May 31, 2016

Re: FirstLight Hydro Generating Company, Turners Falls Hydroelectric Project (FERC No. 1889) and Northfield Mountain Pumped Storage Project (FERC No. 2485).
Response to Stakeholder Requests for Study Modifications and/or New Studies Based on the Study Report and Meeting Summary

Figure 4.1-2A. Cabot Station, Station No. 1 and Turners Falls Dam Discharge (cfs) throughout the 2015 shad spawning survey period.

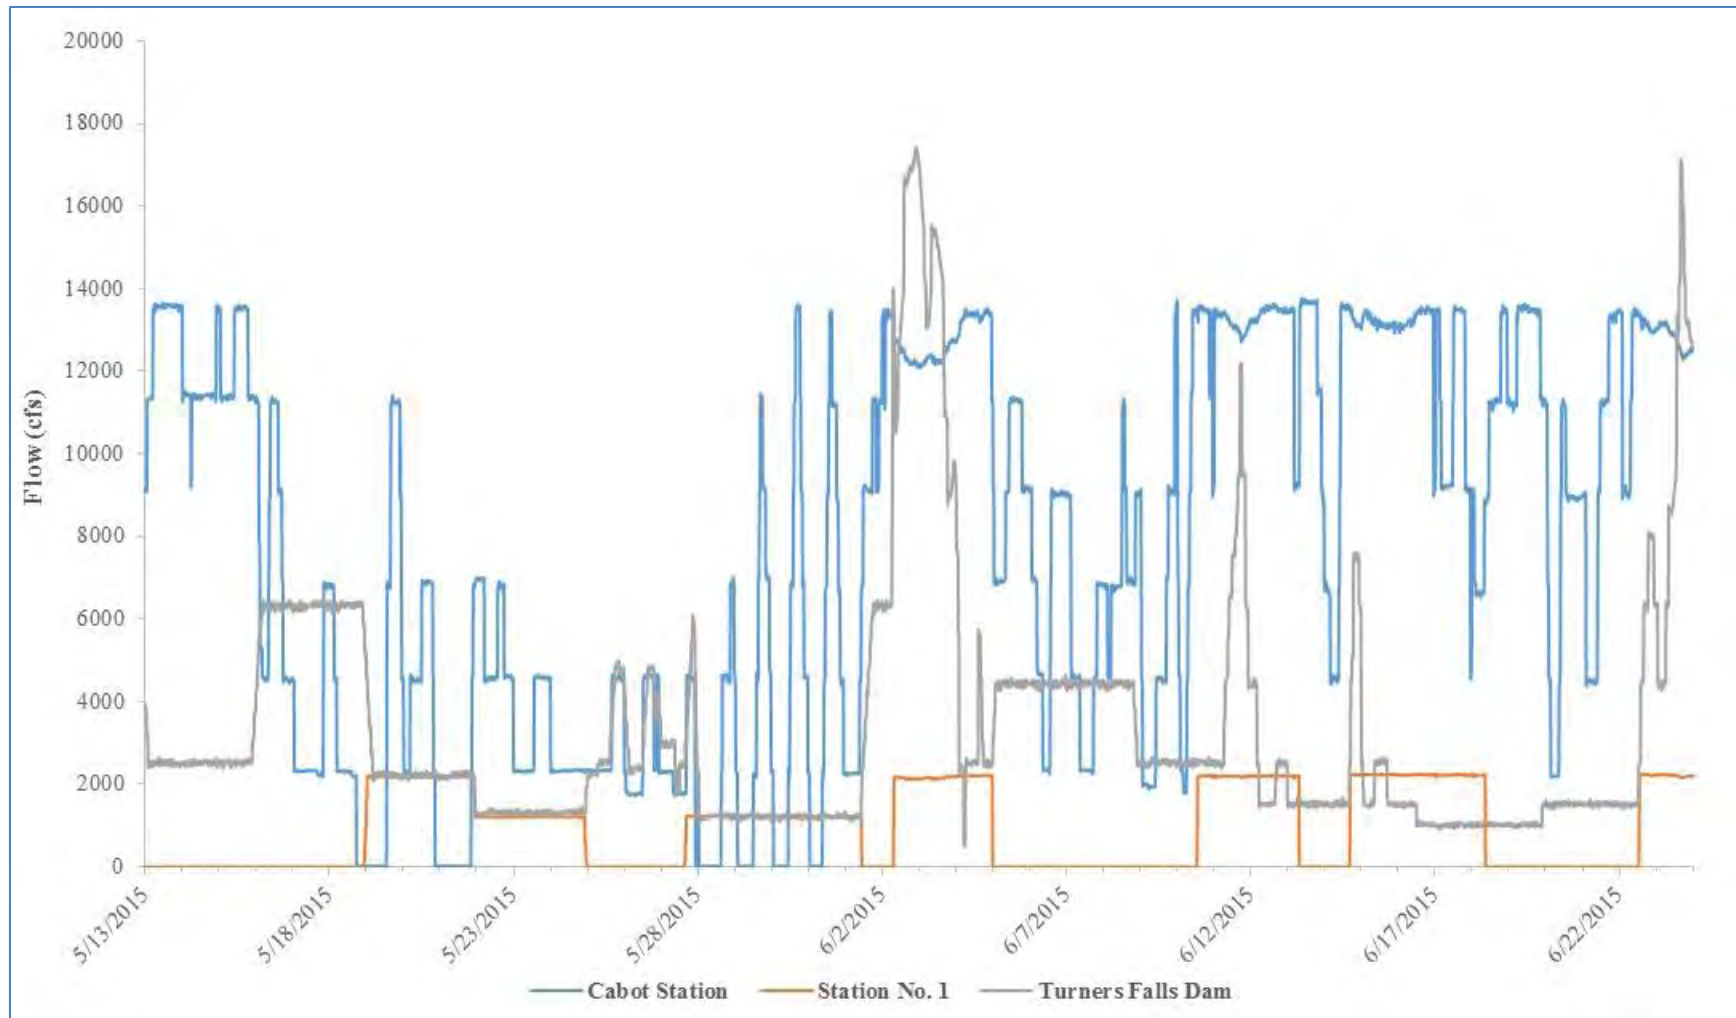
<p>Figure 4.1-2 clearly demonstrates rapidly fluctuating flows and numerous flow reversals based on 15-minute flow data (Zimmerman <i>et al.</i>, 2010). However, the spawning observations were only analyzed by number of splashes and did not take into account the proportional changes in discharge from project operations within the period of observation. An analysis of the proportional change in river flow using the 15-minute USGS flow data at Montague as well as the proportional change in splash counts should be evaluated and discussed in the relicensing study.</p>	<p>See USFWS-7.</p>
NMFS-7	<p><u>Project Operation and Spawning Activity</u></p> <p>The report does not take into account the project operations that were occurring as part of Relicensing Study 3.3.2 whereby bypass flows were being altered throughout May and June. On March 8, 2016, a data analysis workshop was held for Relicensing Study 3.3.2. The color coded calendar indicating the bypass flows that occurred during the radio-telemetry study should be included in section 4.2.3 of the shad spawning study. We consider flows in the bypass reach, in addition to how many units at Cabot Station are operating, as an important project operation that was not considered, analyzed or explained in this report.</p>	<p>Minimum, maximum, and mean flow in the bypass reach is provided in Attachment A to Study No. 3.3.6 and reflects the flow manipulations that were being conducted in support of Study No. 3.3.2. Cabot Station, Station No. 1 and Turners Falls Dam Discharge (cfs) throughout the 2015 shad spawning survey period are included as Attachment C of Study 3.3.6.</p>

Figure 4.3.1-1A: Histogram of log-transformed ($\ln(x)$) splash counts before and after changes in Cabot Station generation.

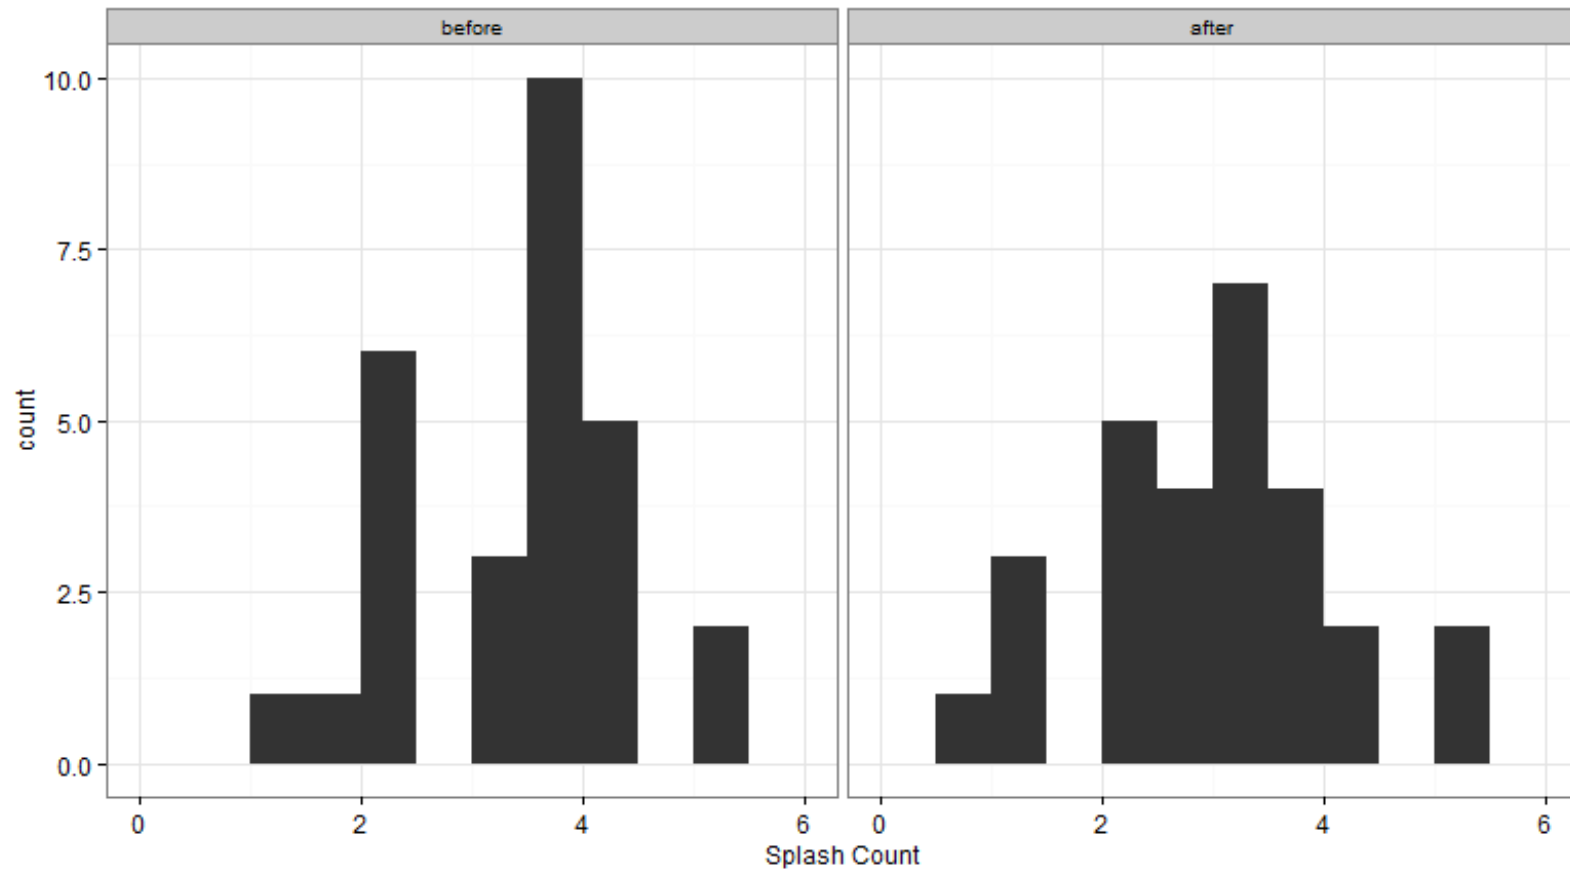
Commenter	Comment	Responses
NMFS-4	<p><u>Project Operation and Spawning Activity</u></p> <p>FirstLight reports that “the negative binomial model found no statistical difference (p=.302) in the mean splash counts before and after changes in generation at Cabot Station.” However, the study design does not include a robust sample size (13 treatment observations and only 1 control observation) or a power analysis to detect a change in splash counts at the p=0.05 level. Therefore the study report does not support this analysis.</p>	<p>FL conducted the regression analysis to find the driving causes behind seasonal spawning intensity and found that the counts were dependent upon time (Durbin-Watson test was significant). When this occurs, results from regression analysis are invalid. During questioning at the study report meeting in March 2016, FERC suggested conducting a paired t-test on splash counts before and after operations change for the 28 paired observations. To conform to the assumptions of the test, count data were first transformed with the natural logarithm (see Study 3.3.6 Attachment D, Figure 4.3.1-1A). The resulting mean and variance of the before counts were 3.41 and 0.99 respectively, while the mean and variance of the after counts were 3.02 and 1.18 respectively. Attached as Study 3.3.6 Attachment D is a histogram of the natural log transformed before/after counts. The paired t-test was significant (t = 4.124, df = 27, p < 0.001) suggesting a difference in counts after operational change; however this is expected as the after counts are always recorded at a later time. As this first test incorporated all operational changes, regardless of whether or not there were increases or decreases in generation, we then examined each operational scenario, log transformed the counts, and applied the same paired t-test (see Study 3.3.6 Attachment G). In every case, the after mean was lower than the before mean, even when no change in generation occurred. The data suggest that spawning intensity decreases throughout the night regardless of the operational changes at Cabot Station.</p>
